ADDENDUM #2

Reference: Price Liquor Store – New Lift & Door Replacement

DFCM Project # 06059030

PRICE LIQUOR STORE NEW LIFT & DOOR REPLACEMENT

AE-502

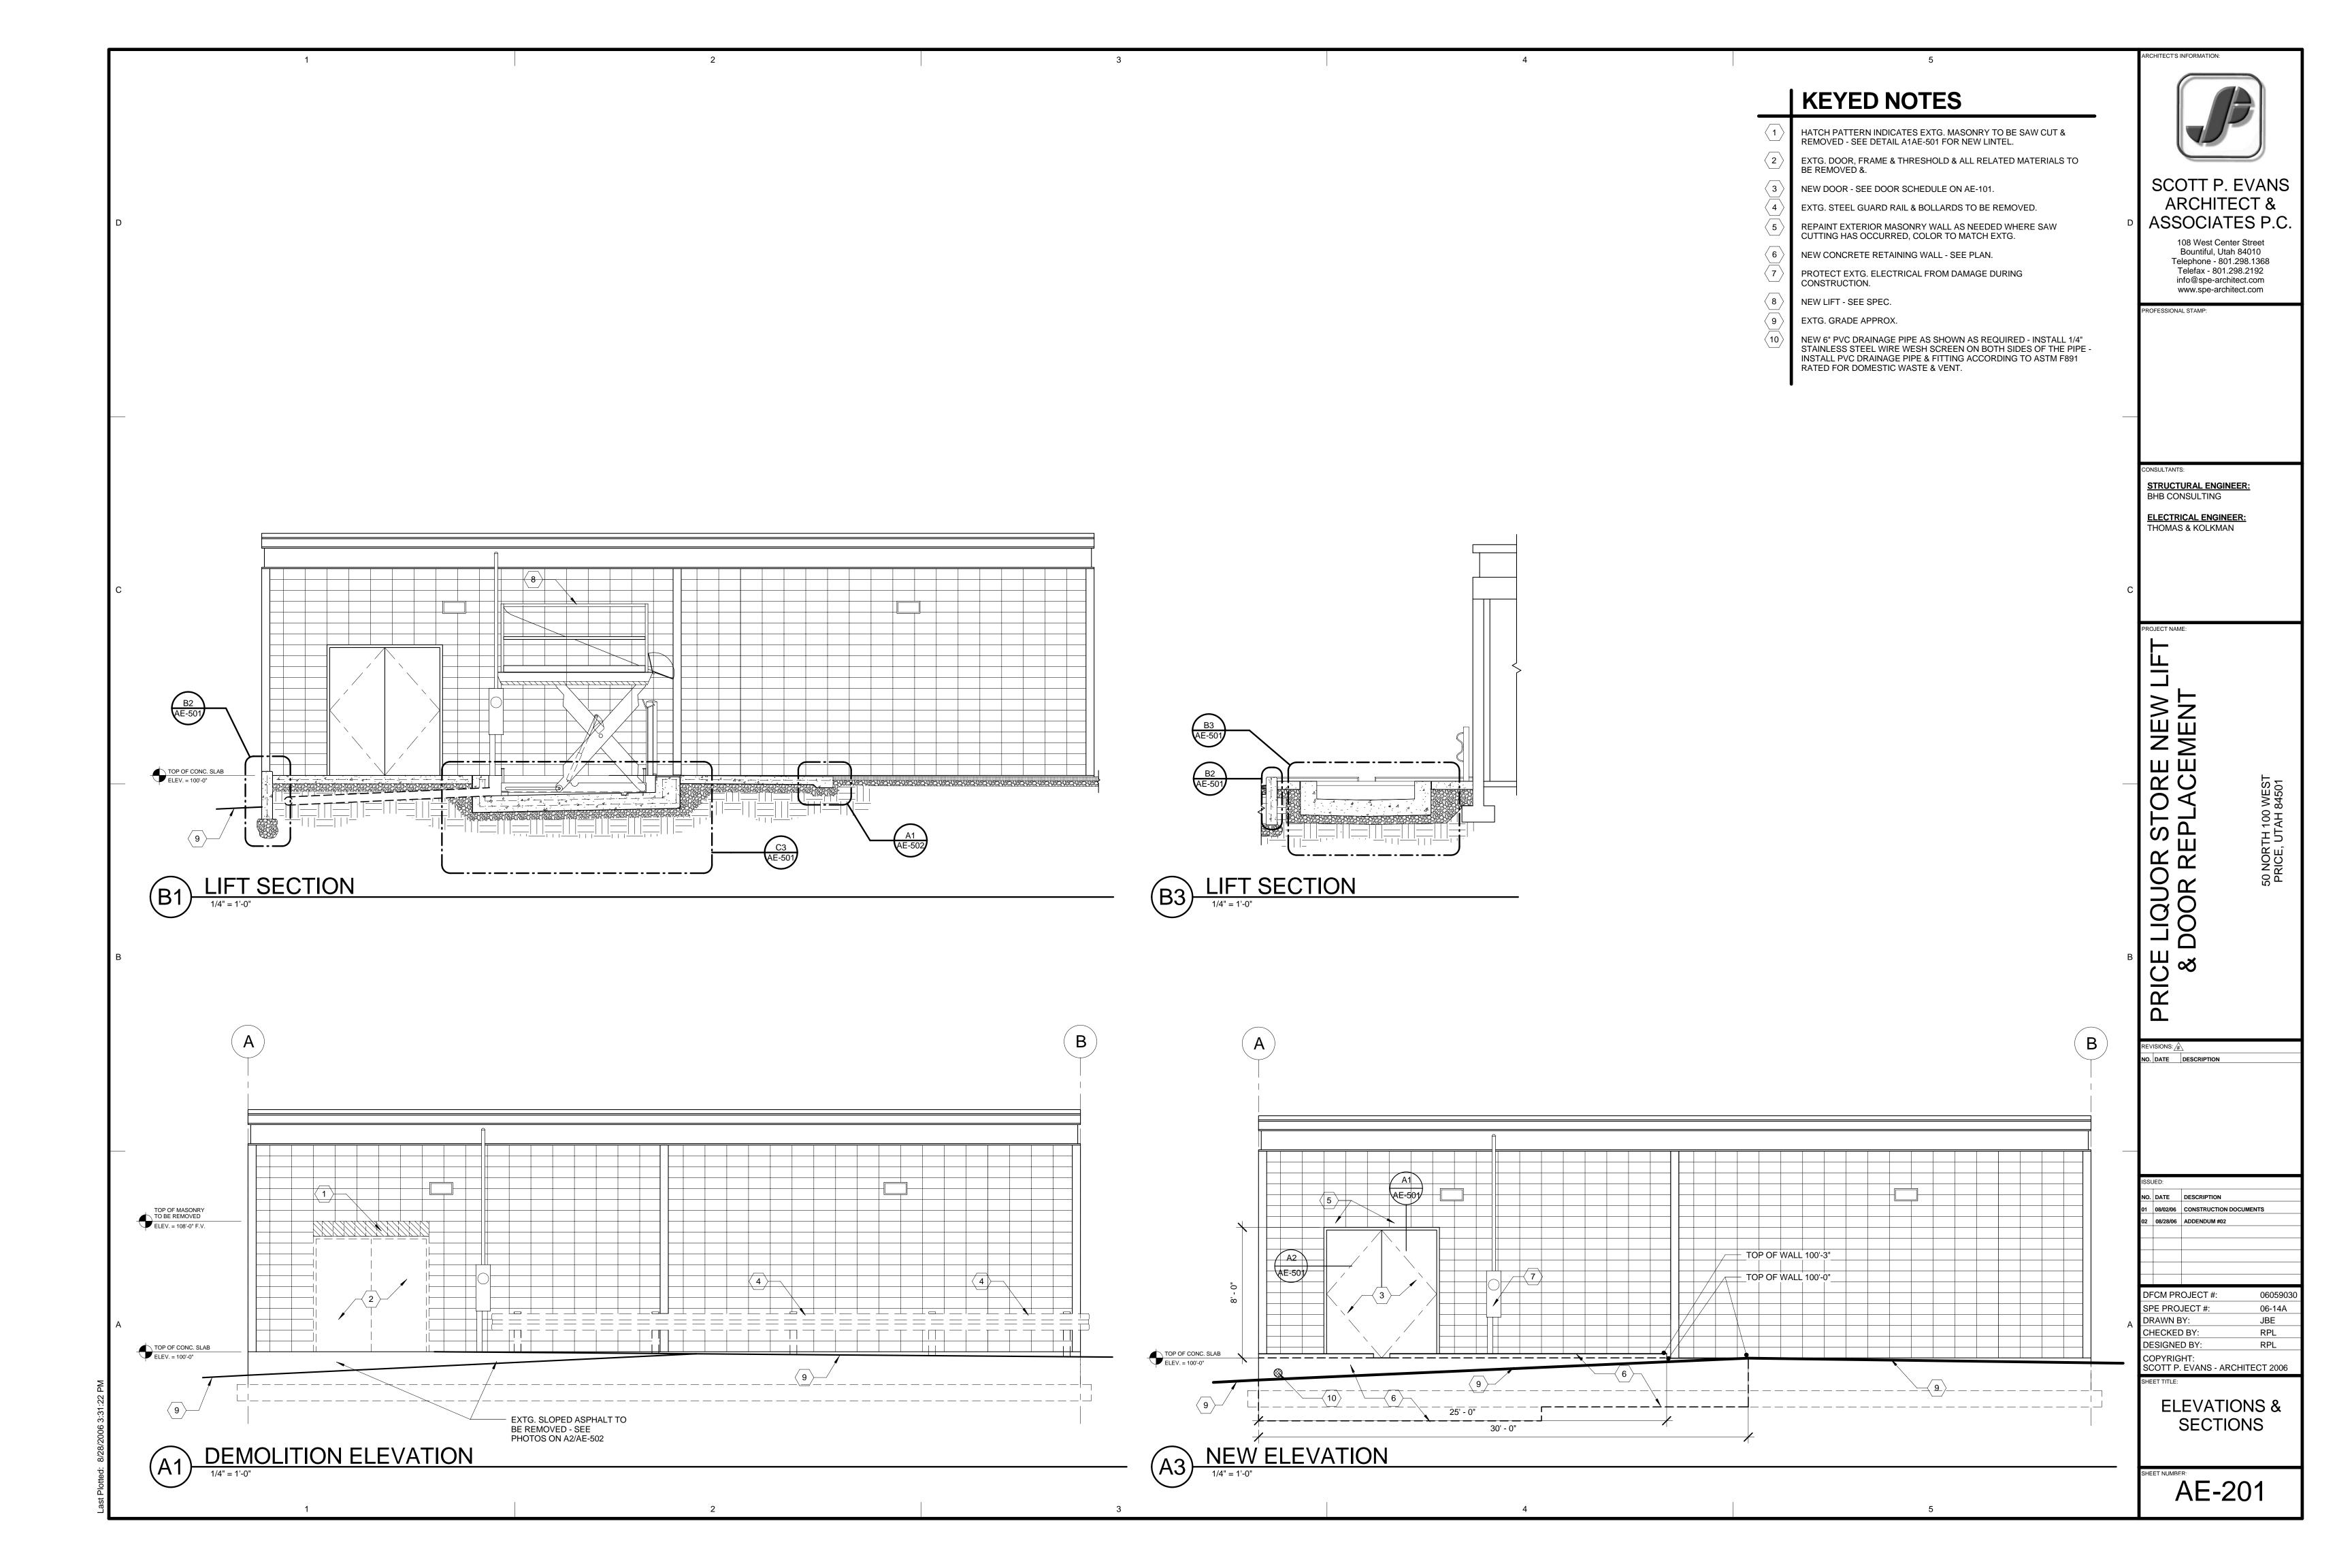
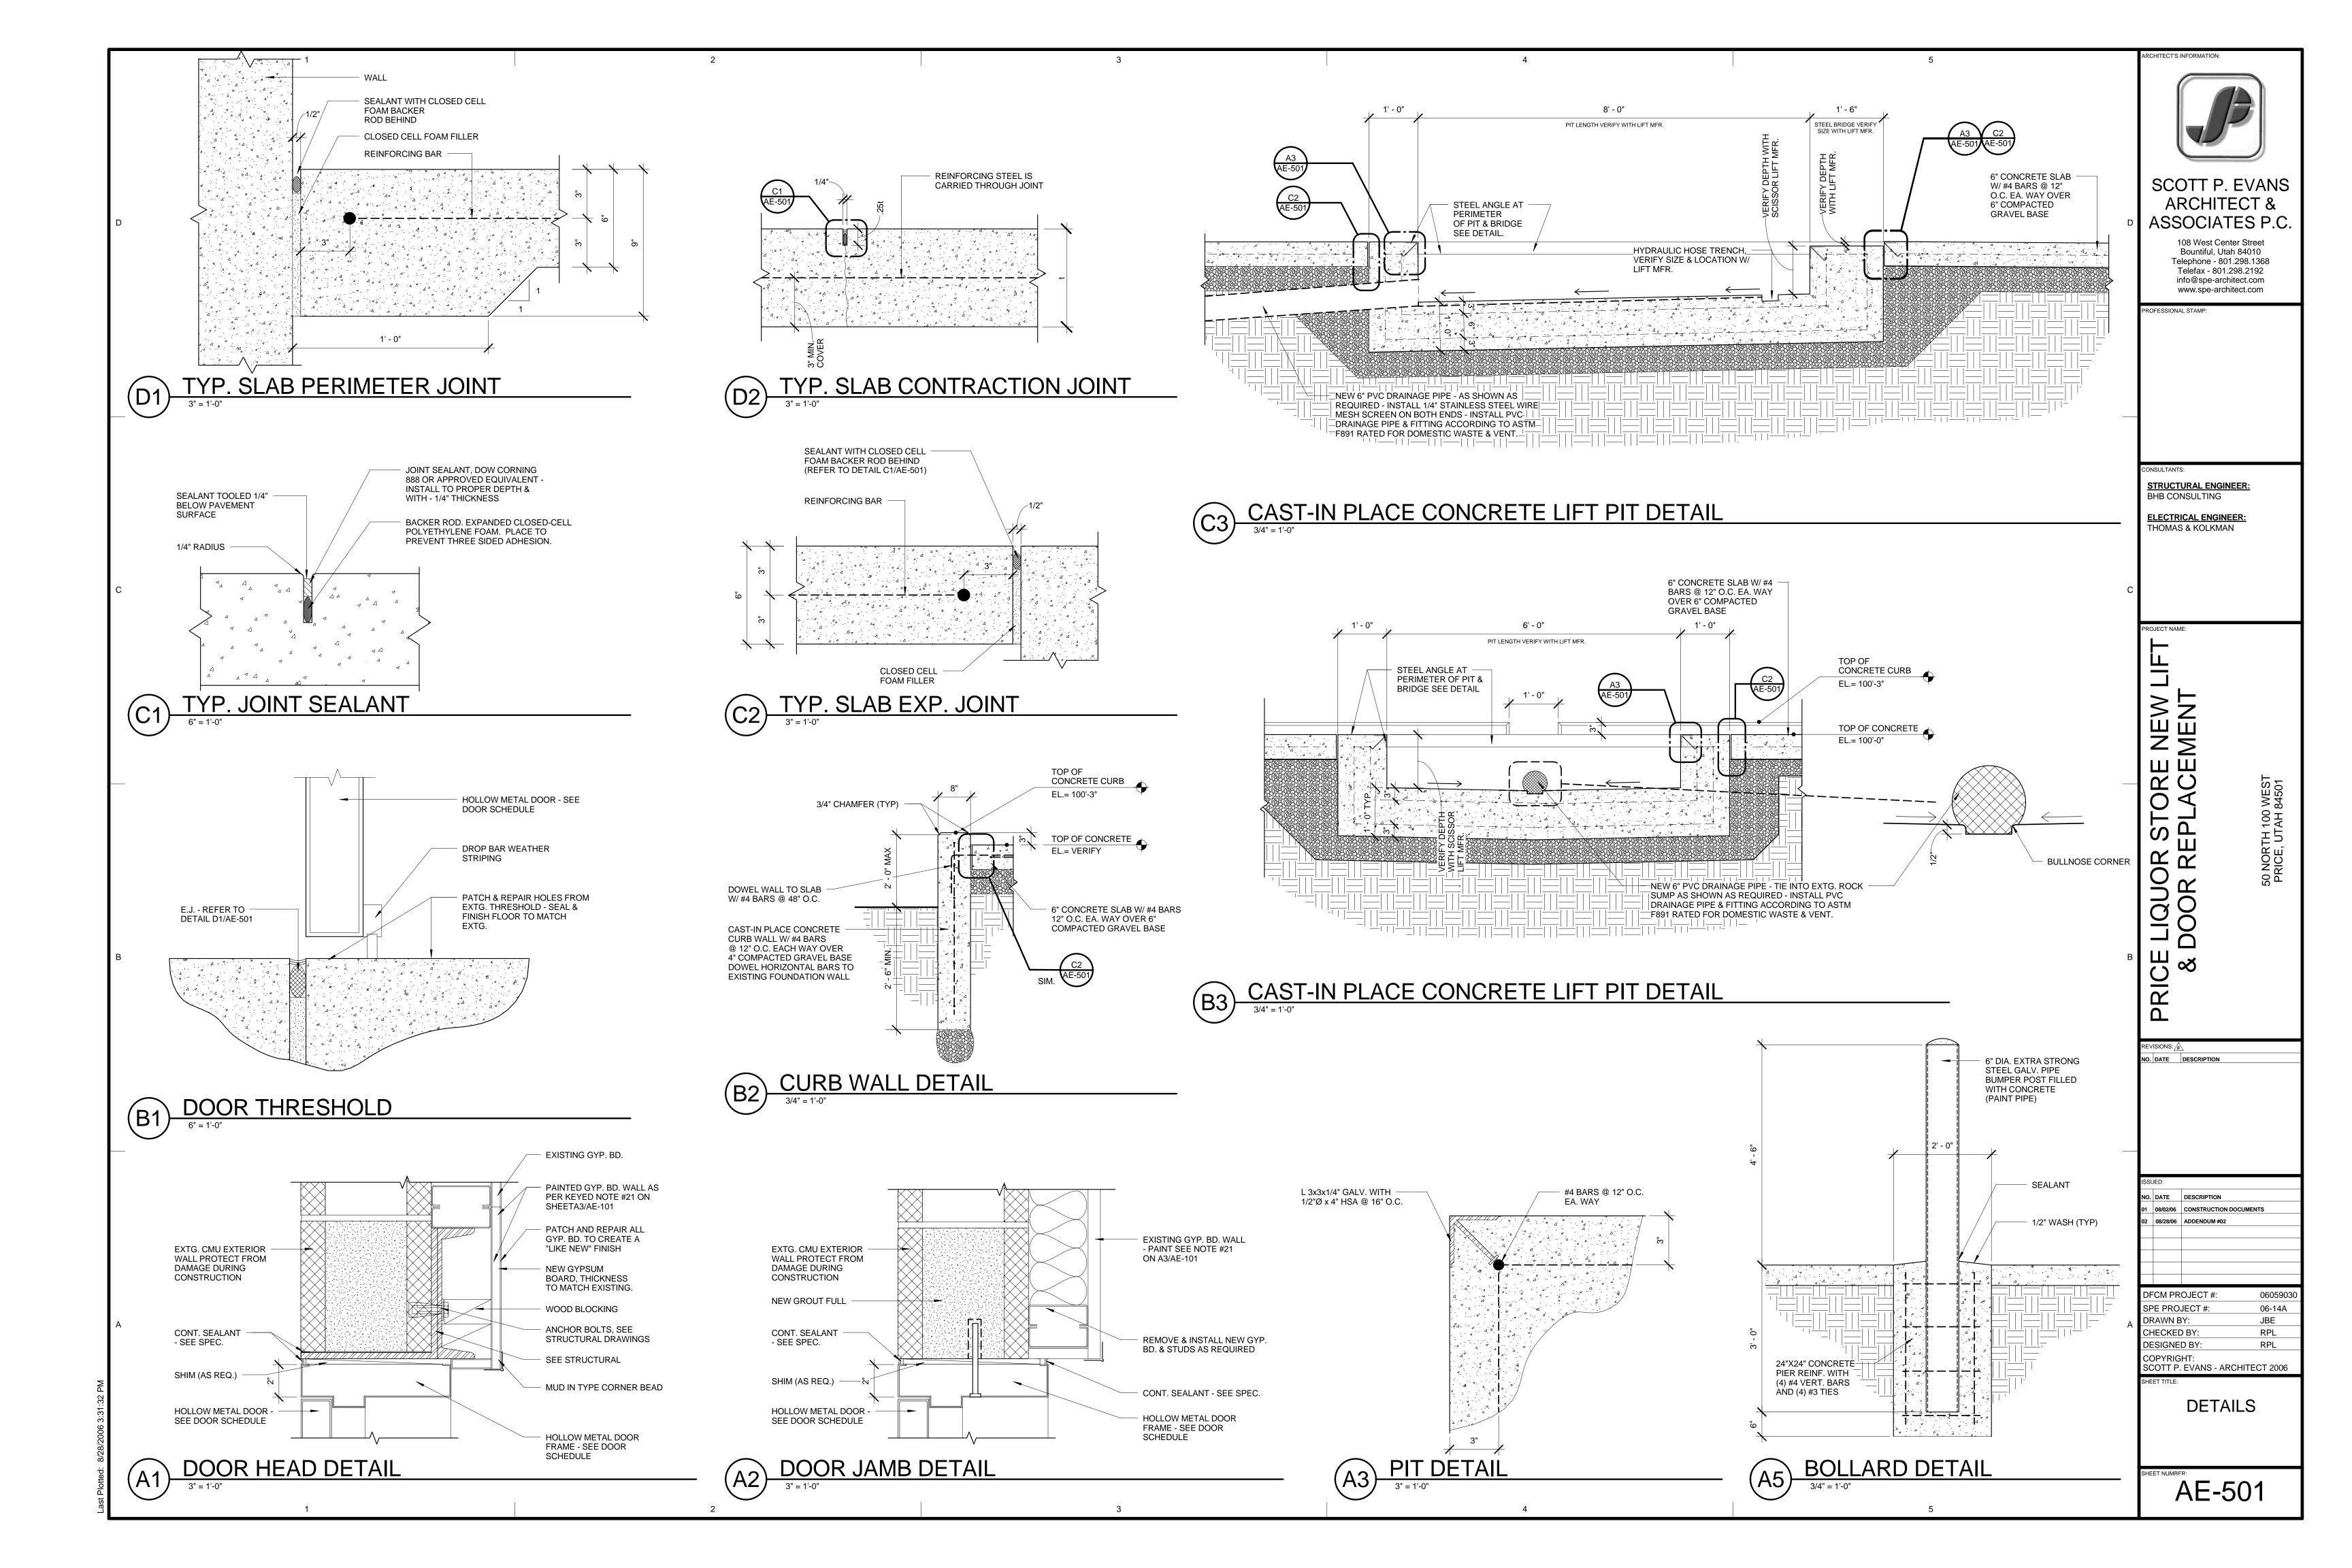
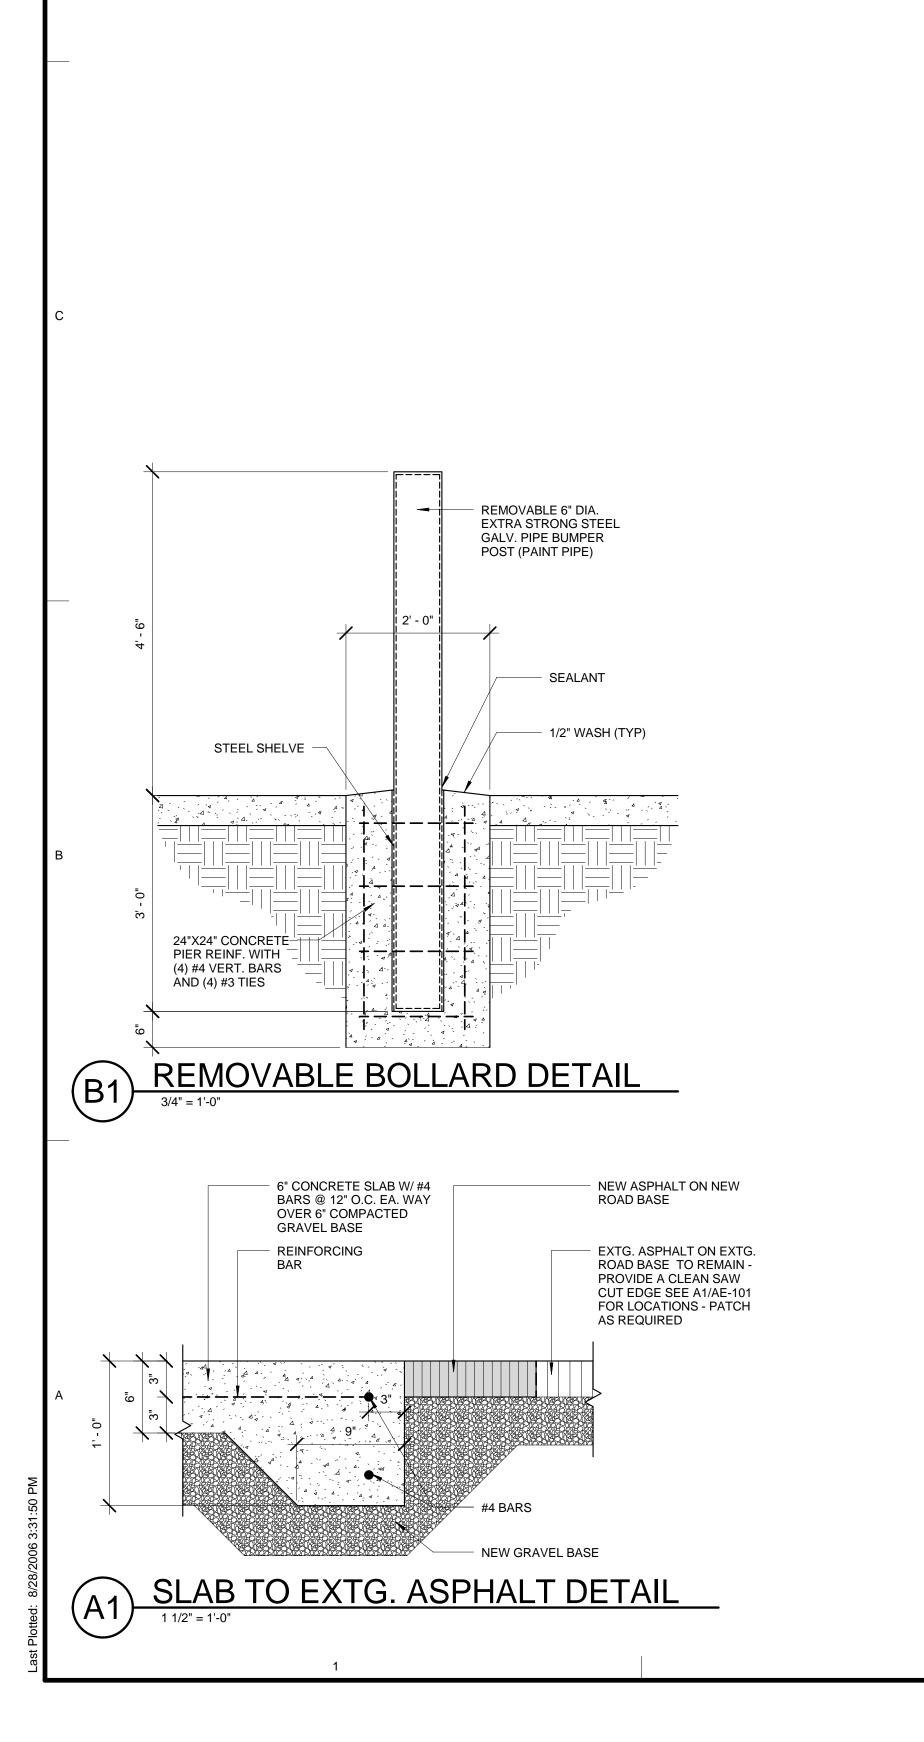
5. ARCHITECTURAL DRAWING AE-502 (REVISED): DETAILS AND PHOTOS (SEE ATTACHED)

- a. Change to plan and keyed notes:
 - 1) Door Schedule relocated to this sheet..
 - 2) Review drawing for any additional changes or notes.
